469-483 Balmain Road, Lilyfield

Submission to PP_2017_IWEST_018_00

This submission has been prepared by ae design partnership in response to the planning proposal (PP_2017_IWEST_018_00) for 469-483 Balmain Road, Lilyfield (**the site**).

As demonstrated by the aerals to the right (**Figures 2-5**), the examples selected are located in medium to high density areas which are appropriate locations for large built forms, not low density areas such as Lilyfield (**Figure 6**).

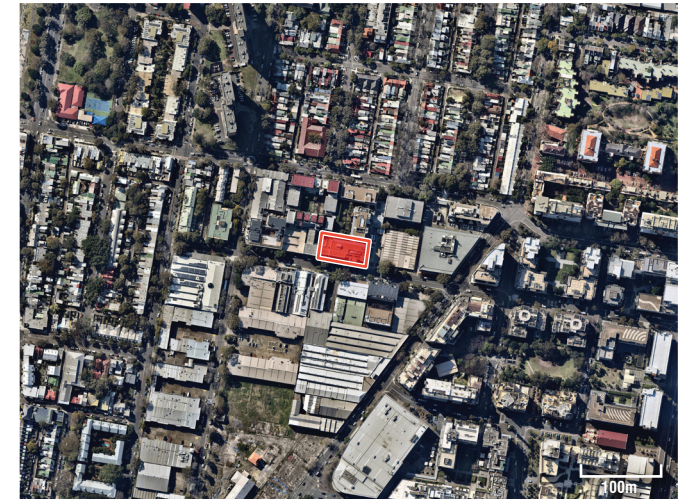
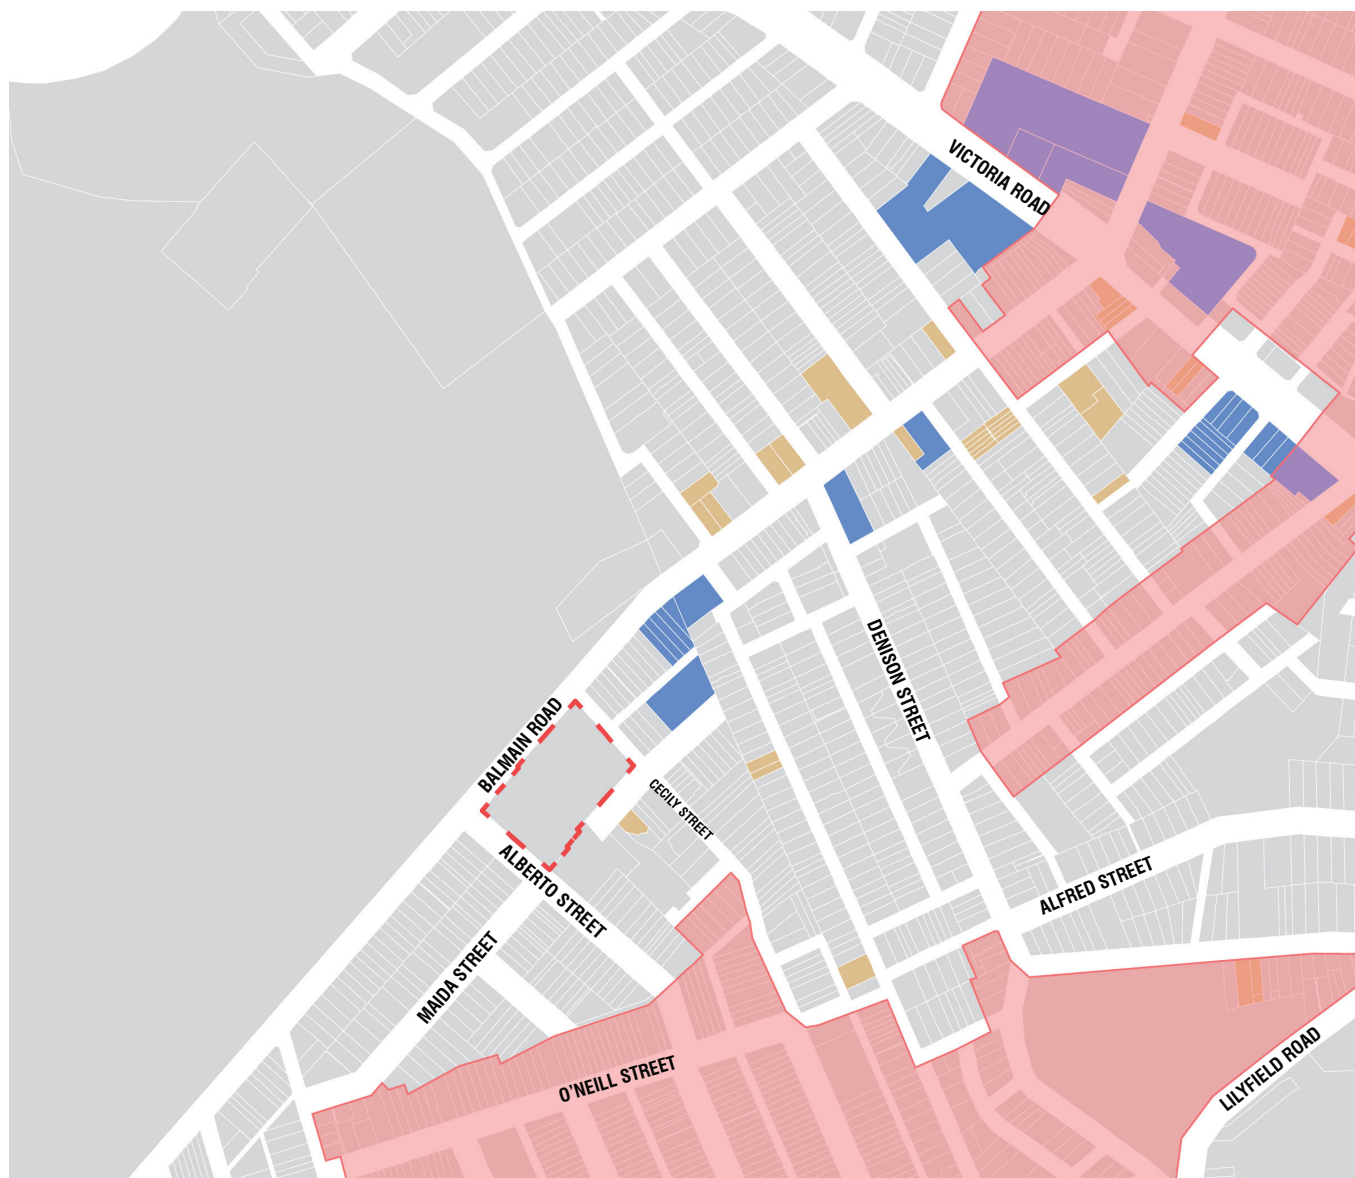
The urban design report provides a number of case study precedents located within Australia and overseas. Yet there is no justification as to why these precedent examples have been selected by Roberts Day.

Our review indicates there may be some relevance regarding the types and mix of building uses. However, there is no justification in support of the scale of the proposed built form.

Figure 9: Proposed Urban Block Concept (adapted from Roberts Day UDR) pg.66)

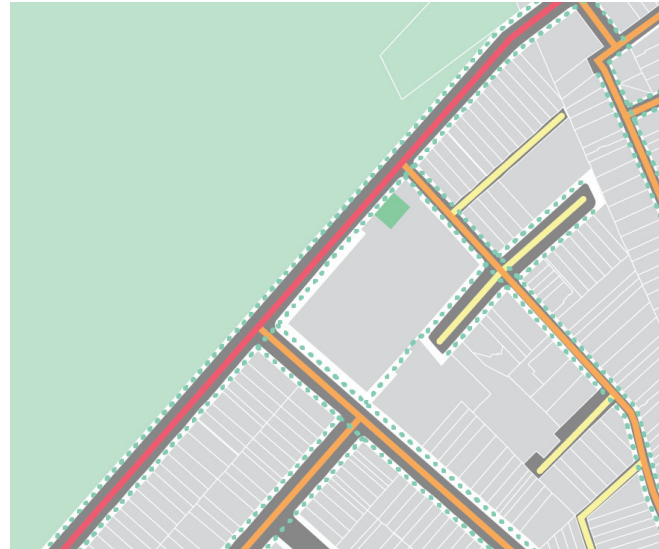
- widening the existing footpaths; and
- providing a pedestrian link between Fred Street and Alberto Street.

Figure 10: Preferred Urban Block Outcome

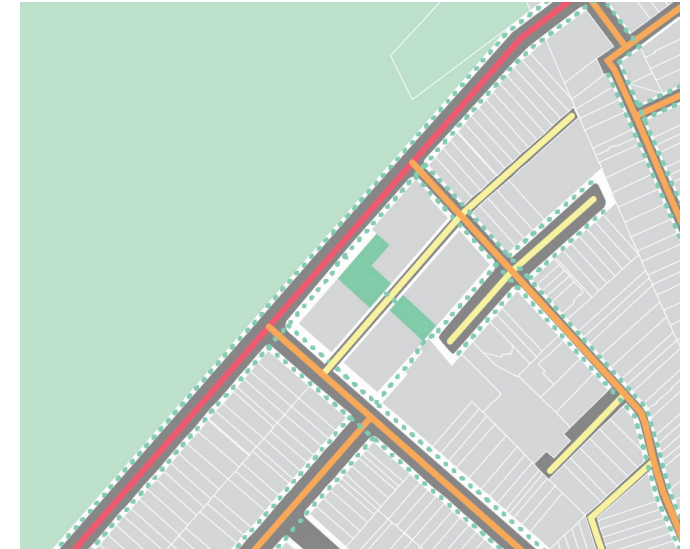
This would result in four potential parcels which could be developed upon.

Figure 12: Proposed Built Form Concept
(adapted from Roberts Day UDR)

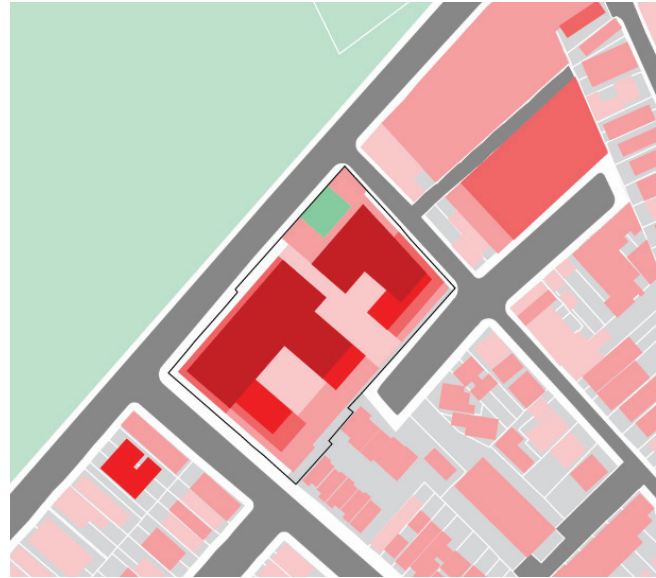
- provides an overall building height consistent with other buildings in the vicinity of the site;
- presents a two storey street wall height which is compatible with the existing streetscape;
- provides significant setbacks for the third storey ensuring it is not visible from the pedestrian perspective;
- provides open space along the ground plane ensuring it is easily accessible and of high amenity;
- improves the vehicular and pedestrian permeability of the locality; and
- retains the existing character buildings of the site.

Figure 13: Preferred Built Form Outcome

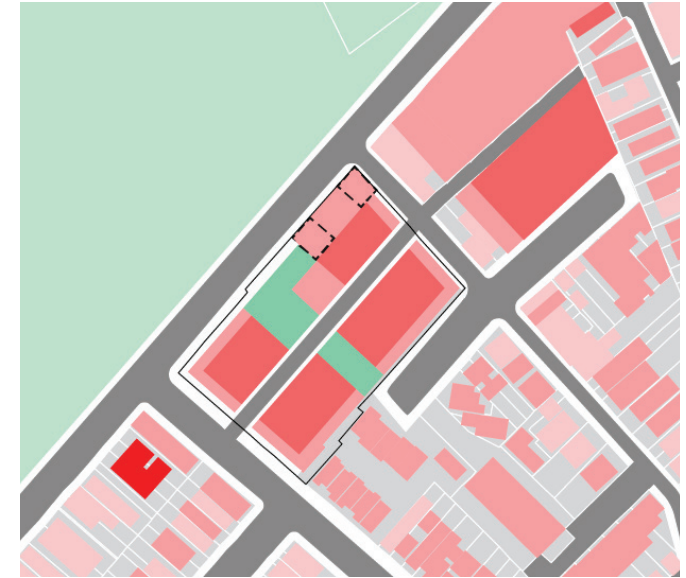
The preferred outcome shown in **Figure 13** presents a two storey streetwall along Balmain Road with a third storey well setback from the street. This presents a much better built form outcome which is compatible with the existing streetscape and local character.

Proposed Streetscape

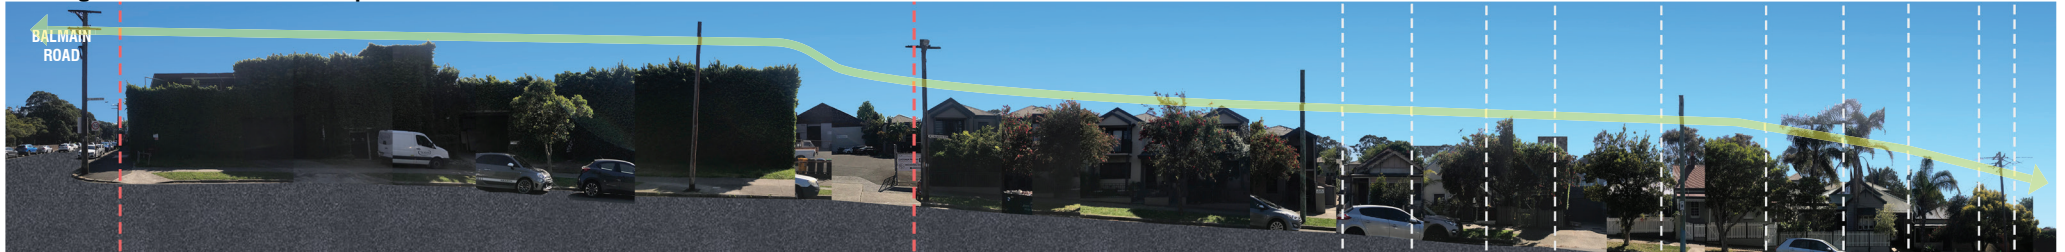
While the proposed two storey street wall height is supported, the upper levels will be visible from the pedestrian perspective presenting a built form that is completely out of character with the existing streetscape.

Figure 23: Preferred open space location

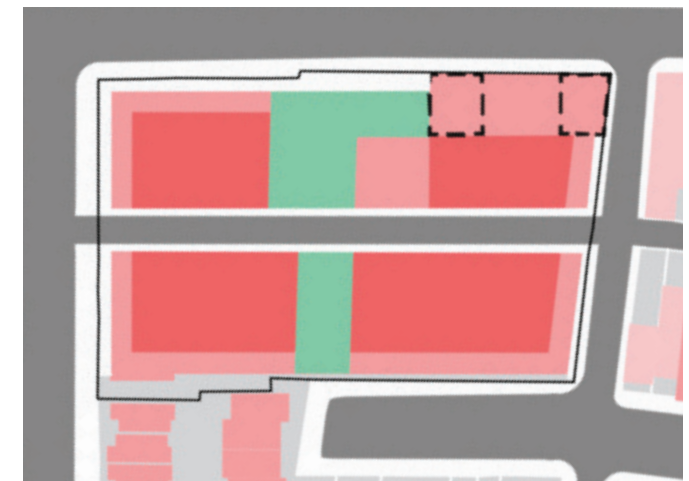
Given the sites large area, open space should be provided along the ground plane consequentially creating a through site link and separating built forms as demonstrated in **Figure 23**.

Figure 24: Solar analysis diagrams (source: Roberts Day UDR pg.79 & 79)

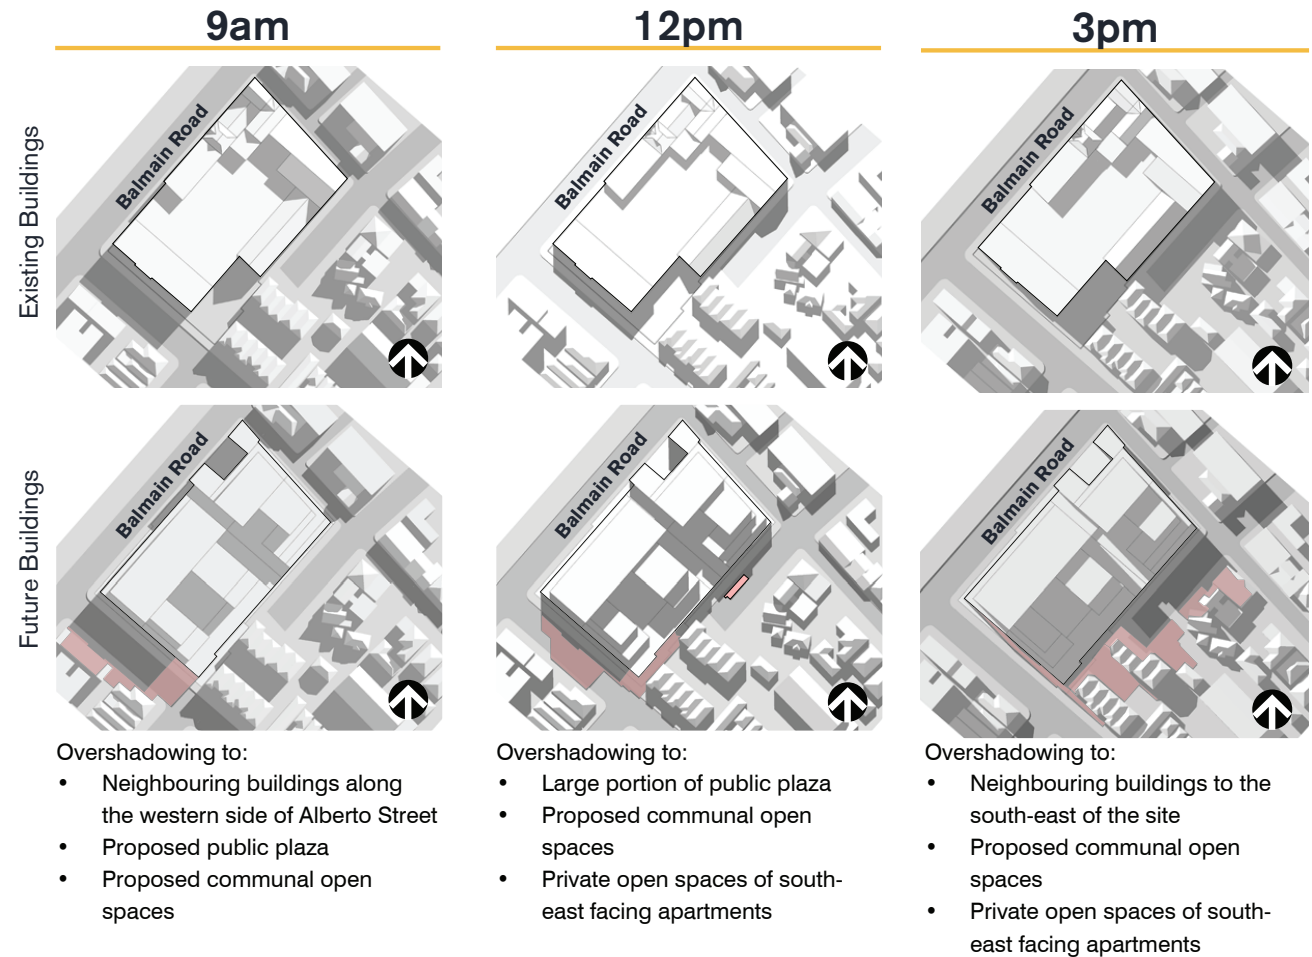
The proposed communal courtyards (highlighted in red in **Figure 22**) will receive no direct sunlight at any time throughout the day (see solar analysis diagrams on the following page). This renders them non-compliant with Objective 3D-1 of the ADG which states that:

- The proposal will create significant overshadowing impacts to neighbouring properties along Alberto Street and Fred Street.
- The communal open space areas within the site will be of extremely poor amenity as they will receive no direct sunlight at any time throughout the day.
- The private open space of apartments overlooking Fred Street will be in shadow from 10am onwards.

Figure 25: Proposed LEP height control (source: Roberts Day UDR pg.85)

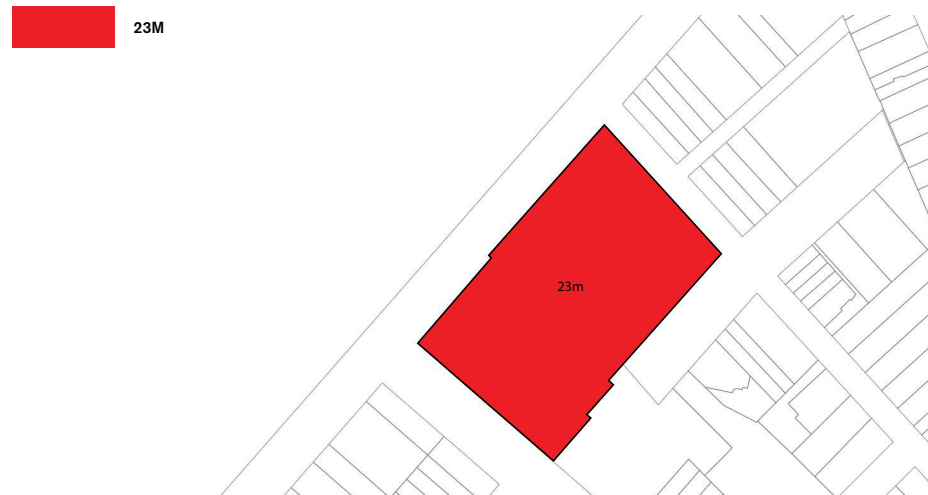
The proposed controls do not provide enough restriction to ensure that future development is not of a larger scale than the proposed massing illustrated in the report.

The proposed maximum building height across the site is 23 metres and the built form controls in the proposed Development Control Plan only propose 3m upper level setbacks and a 9.55m streetwall height along Fred Street.

Figure 1

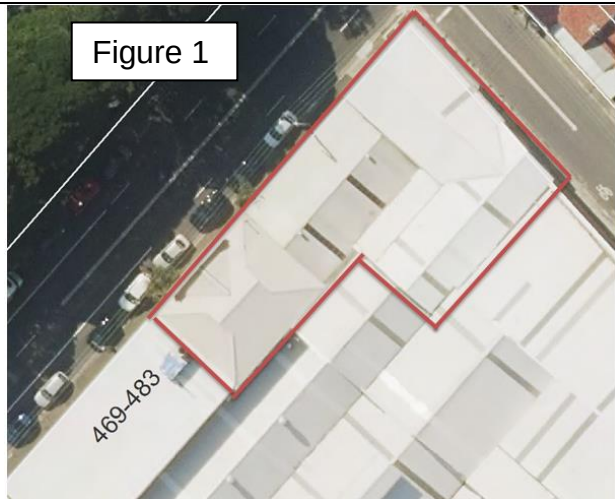
The ABBCO office building, Pilchers Bakery (2 storey brick building on the corner of Balmain Road and Cecily Street) and the connecting building between these two fronting Balmain Road (refer to Figure 1) are therefore worthy of heritage listing under Leichhardt LEP given their significant fabric and must be protected. The proposed concept design currently shows that a significant part of the Pilchers Bakery building would be demolished and must be amended to show its protection and retention. Council's Heritage Advisor site inspection established that the structural walls, floors and ceilings appear intact. The internal partitions and alterations such as false ceilings are reversible and the original floor plan is recoverable. The condition of these buildings do not warrant demolition.

This will underpin a revision of the Planning Proposal to propose the heritage listing of the ABBCO, Pilchers Bakery and connecting buildings shown in Figure 1.

- d. Protection and conservation of the heritage significant buildings on the site as shown in Figure 1*
- e. A pedestrian through site link between Fred Street and Balmain Road*
- f. Minimum setbacks from the site boundaries to the residential component*
- g. The height of the development should be specified in metres and AHD with provision for greater floor to ceiling heights in the light industrial component. Specifically, the ground and first floor levels related to the non-residential and employment floor space must have a floor to ceiling height of 5.2m, with the ground floor of the development reserved exclusively for employment purposes as part of any redevelopment of the land.*
